Access Compliance Report

Public Rights-of-Way

(Curb Ramps)

Intersection ID: 3307	Main Street: SUTTONVIEW_DR	Cross Street: LOOKOUT_POINT_DR	Location: S
ADA ID: A28C333C93F6	Ramp Type: Perp	Initial Pass/Fail: Pass	Overall Compliance: No
Codes/Mitigation Info/Possible Solution		Field Measurements/Component Compliance	
Severity Score: 2.5

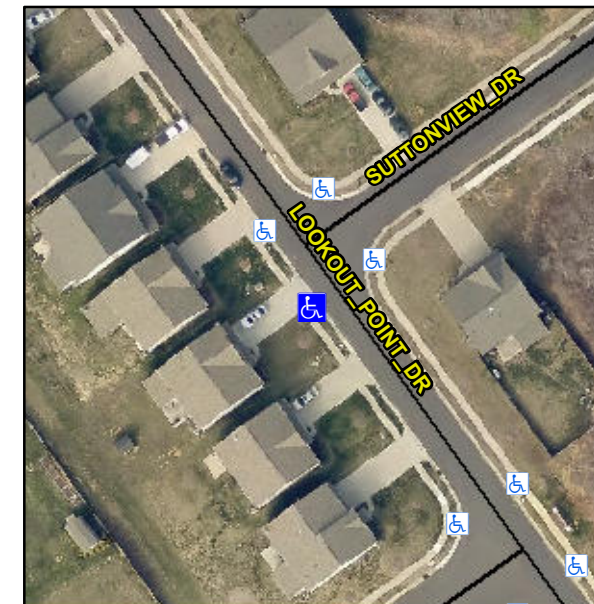
R304.2.1, R304.2.2-Perp, R304.3.2-Para, R305.1.4, R305.2

Remove & Replace Entire Ramp.
